American Honda Motor Co., Inc.

PRODUCT UPDATE NOTICE

BF200D • BF225D • BF250D Outboards COOLING SYSTEM INDICATOR

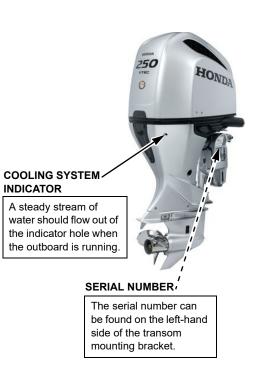
Water may not be flowing out of the cooling system indicator while the engine is running and/or water is seen leaking from the outboard between the engine cover and lower covers.

This condition can damage certain engine components such as the fuel pump, ignition coils, or starter motor, and cause the outboard to not start or operate properly.

Please contact your Honda Marine servicing dealer to make arrangements to have your BF200D, BF225D, or BF250D repaired. The dealer will install a metal retaining clip onto a rubber hose in the cooling system indicator, and if required, perform a multi-point inspection at no charge to you. Transportation of the outboard to the dealer is the responsibility of the owner.
